Civic Design Review Phase 3

Chinatown Station

Chinatown Station Phase 2 approval responses, developments

Chinatown Station updated tree species

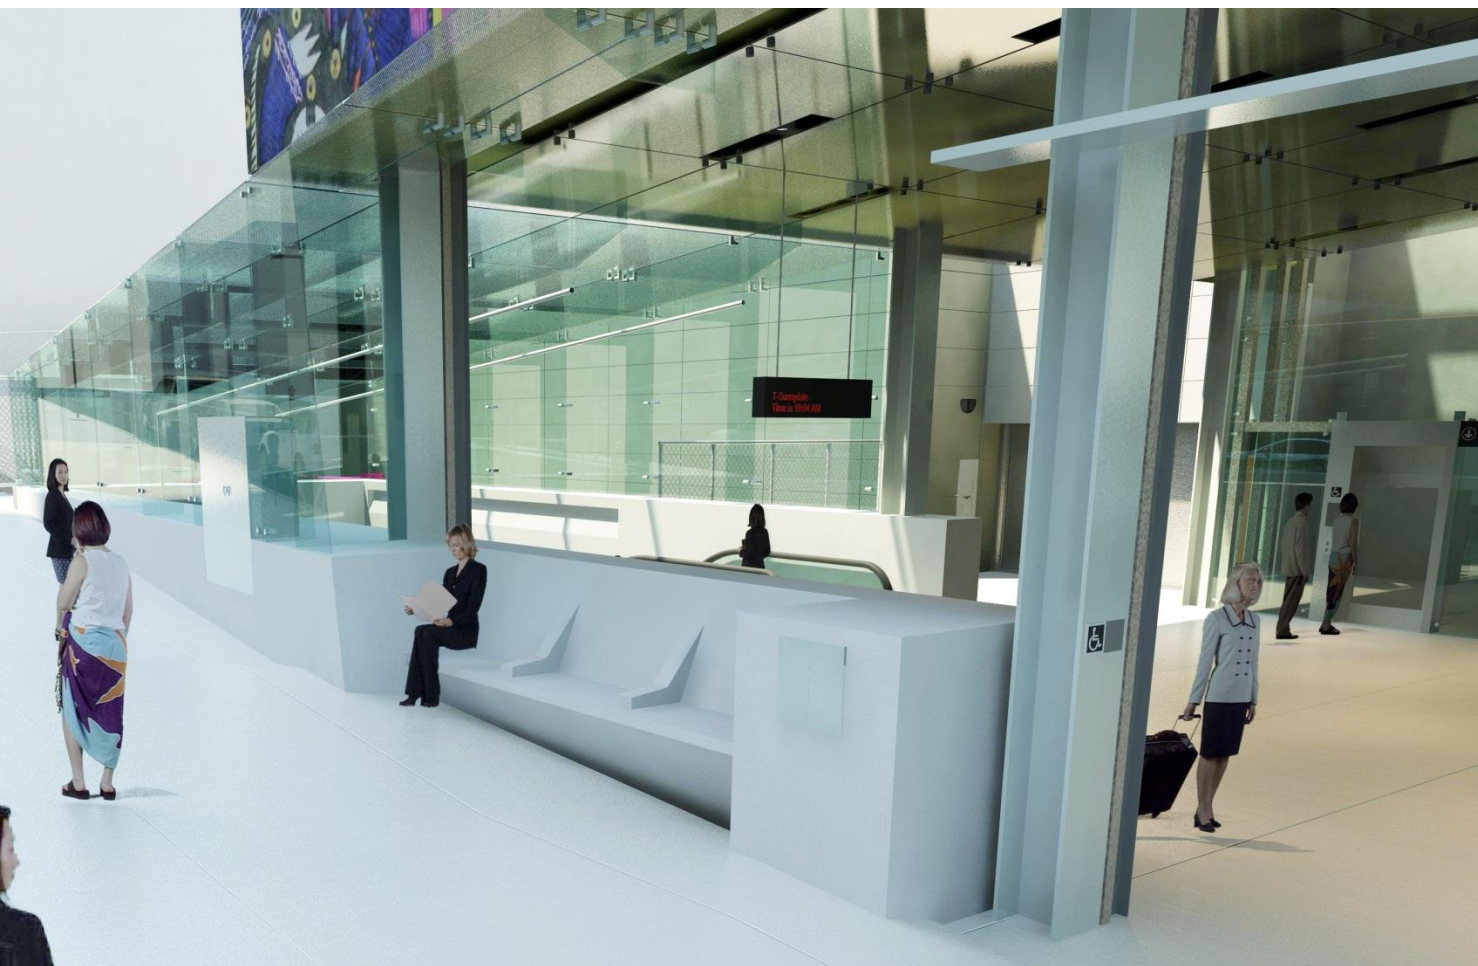
ONE NEW STREET TREE MARKS STATION ENTRANCE

- FORMER PROPOSAL: GINGKO BILOBA
- CURRENT SELECTION: MICHELIA DOLTSOPA "SWEET MICHELIA"
 - EVERGREEN, BLOOMS IN WINTER MONTHS
 - AT MATURITY: MODERATE CANOPY, HEIGHT 15-25FT, SPREAD 15FT
 - SPECIFIED IN CD:12-14FT TREE MIN. HEIGHT, 6-7FT SPREAD MIN.

Chinatown Station entrance at surface

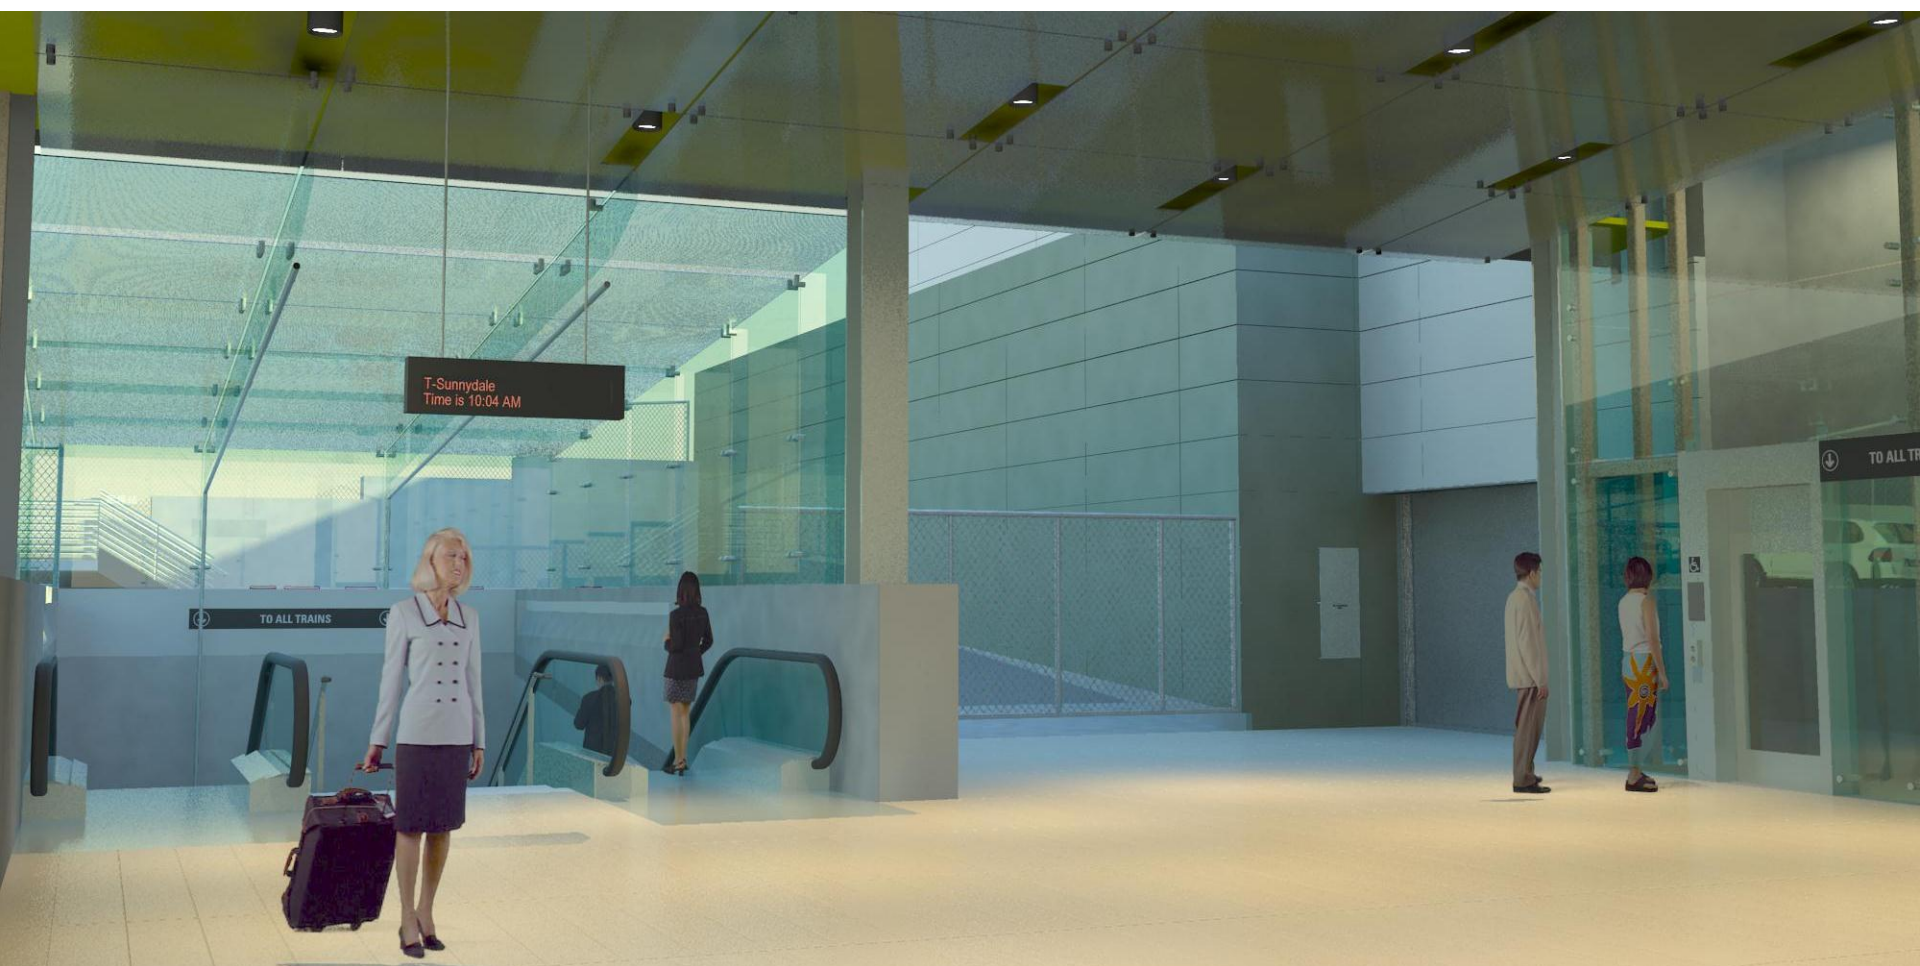
- SUFACE LEVEL
 - REDUCE SIZE OF COLUMNS
 - REVISE SINAGE
 - SIMPLIFY OVERALL DESIGN
 - UNIFY BENCH
 - UNIFY ART/CEILING IN MONOLITHIC SOLID VOLUME
- CONCOURSE LAYOUT TO ACCOUNT FOR CROWDED CONDITIONS
- RESOLVE AND MINIMIZE CAVERN HANDRAILS
- PROPOSE MASSING OF FUTURE DEVELOPMENT
